N400NAS3

# TECHNICAL BULLETIN

Service Action: Startup Battery Ground Stud - Insufficient Ground Contact

MODEL:	MODEL YEAR:	VIN:
Discovery (LR)	2019-2020	400099-418197

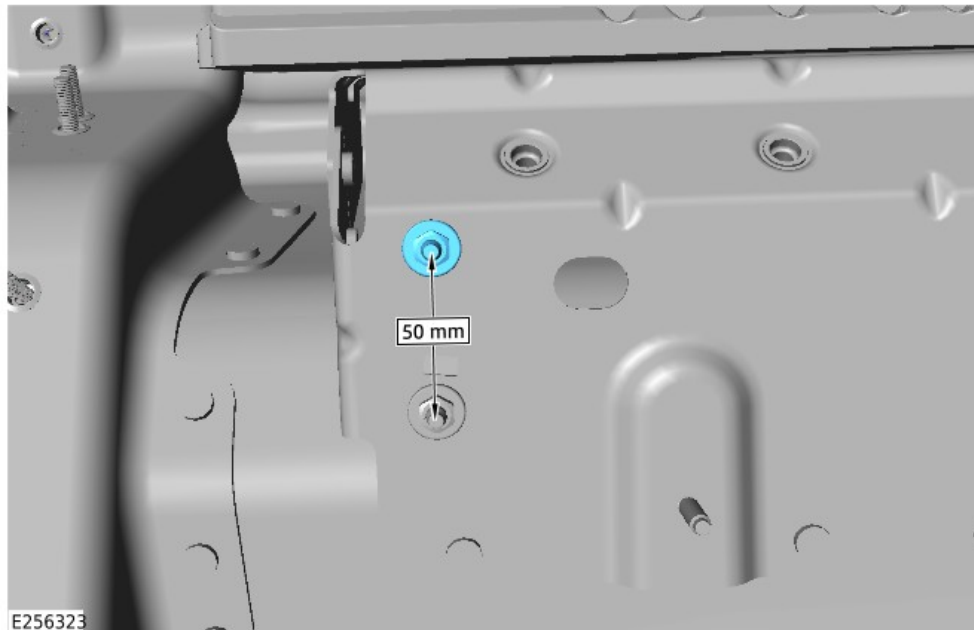
Remove the startup battery ground cable from the body ground stud (G4D178).

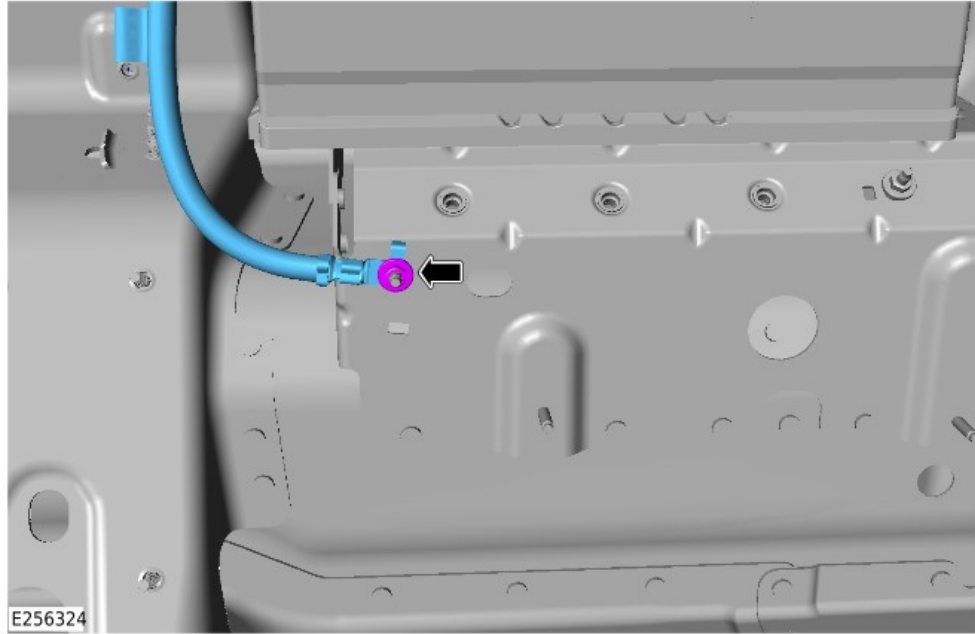
Install a new body ground stud (78905) 50 mm above the existing ground stud (G4D178) (see TOPIx Workshop Manual section 501-25A: Body Repairs General Information - General Procedures - Body Earth Stud Repair).

Install the startup battery ground cable to the new body ground stud.

- Torque: **8 Nm**

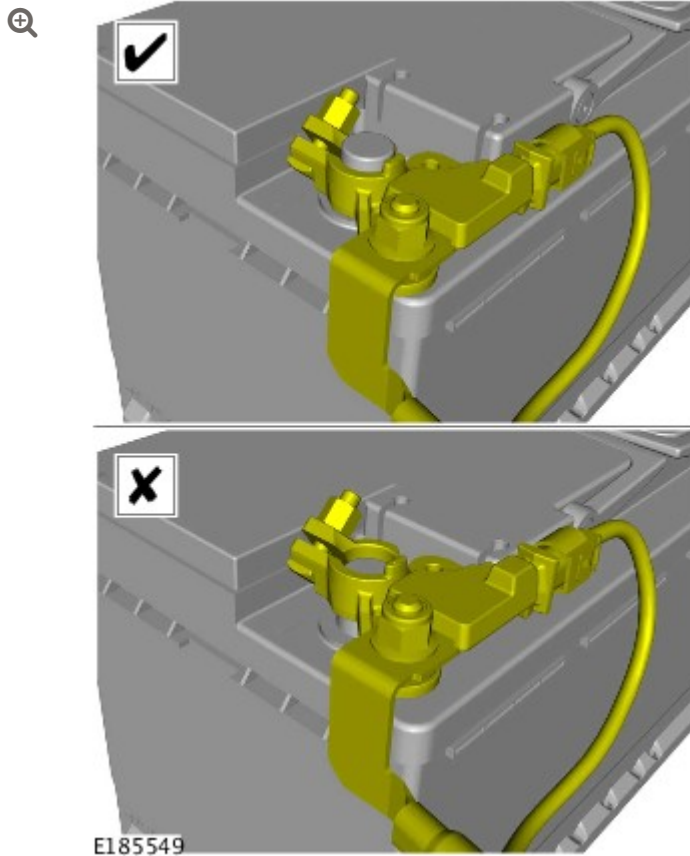
Make sure the battery terminal is in the correct position.

Connect the startup battery ground cable (see TOPIx Workshop Manual section 414-00: Battery and Charging System - General Information - Specifications).
